**To:** Patterson, Leslie[patterson.leslie@epa.gov]; Marshall, Laura[Laura.Marshall@epa.state.oh.us]  
**From:** Loney, Adam  
**Sent:** Wed 3/13/2013 6:51:12 PM  
**Subject:** RE: SDDL Phase 1A outline comments  
[Pages from RI Aerial Photos.pdf](#)

**Subject:** SDDL Phase 1A outline comments

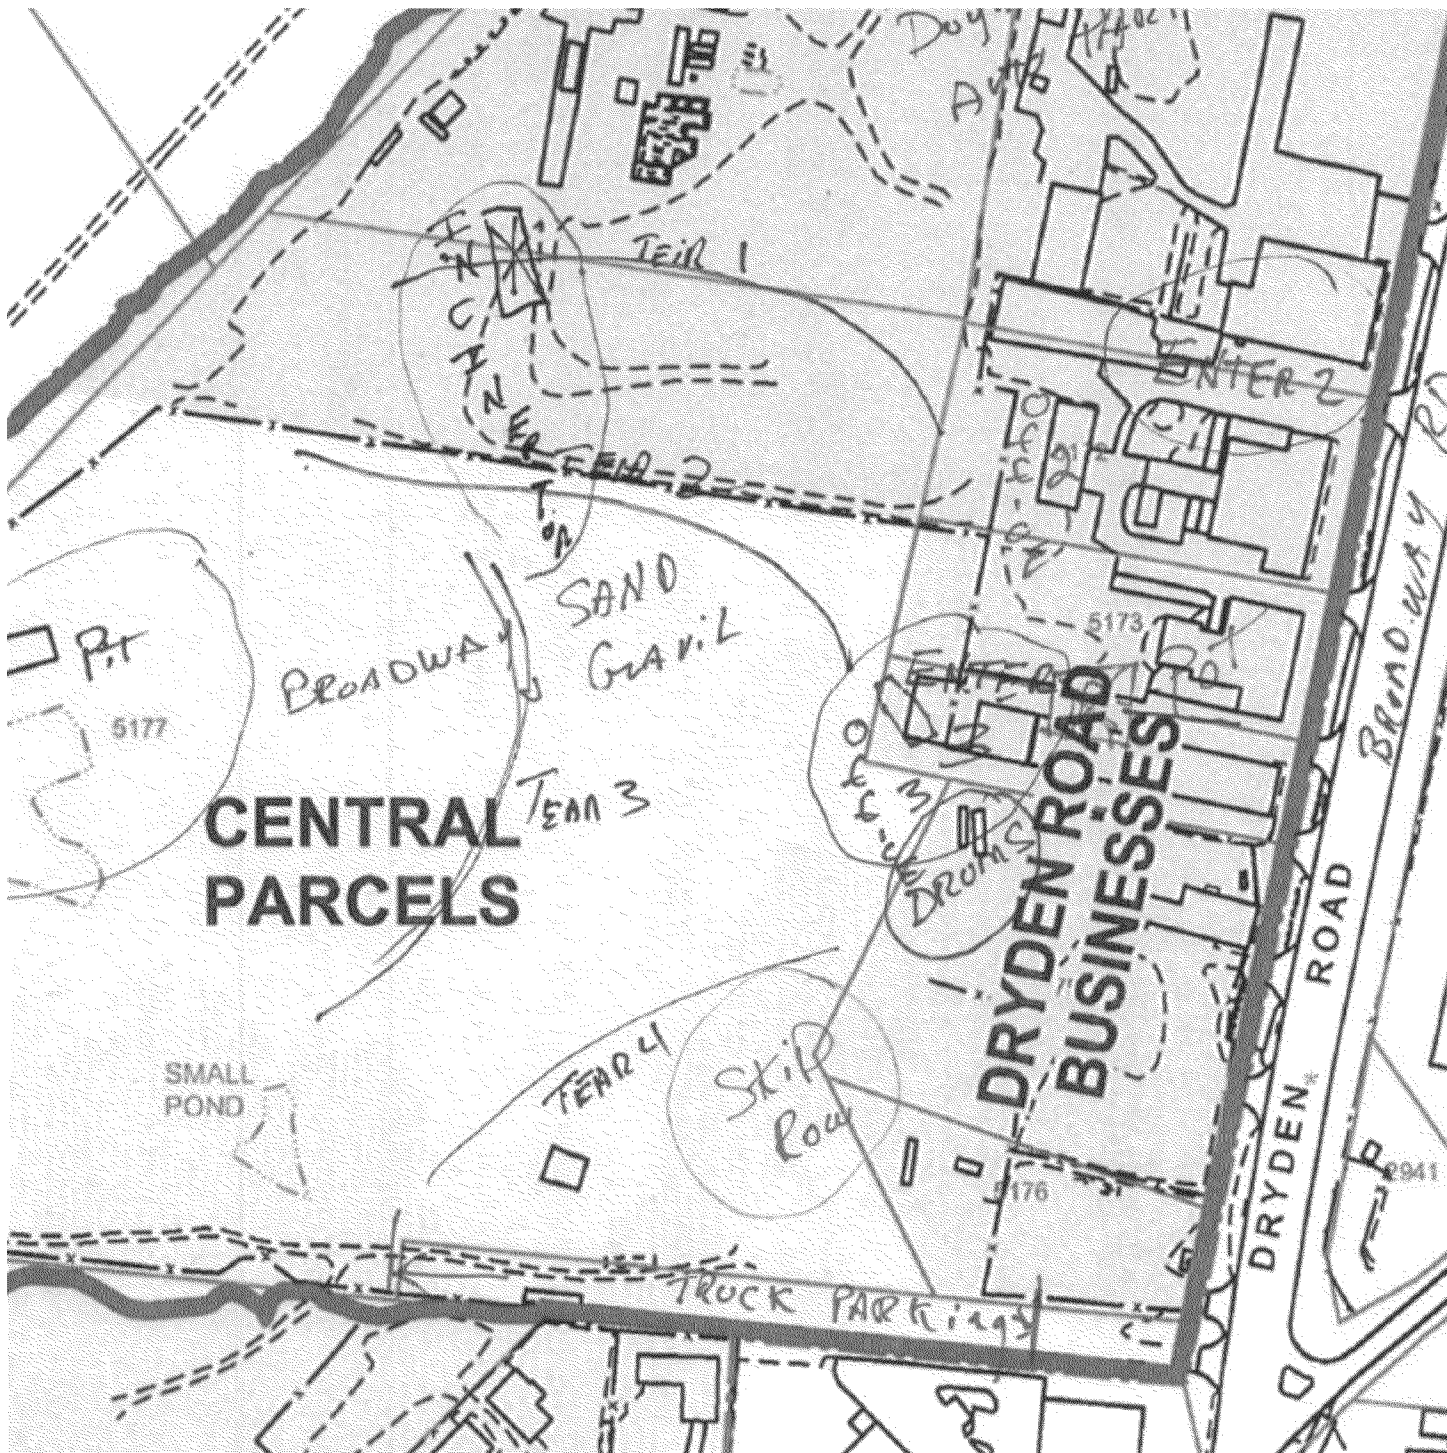
That is one area, I think there are references to others.

Sure, here's the portion of the Grillot deposition Exhibit 2 that shows drums south of the Entrance 3 office. The transcription of the deposition talks about drums dumped "behind" entrance 3 though, so where that might have happened in relation to the office is a bit unclear. The area of concern would be the area around the office down to the area marked "drums".
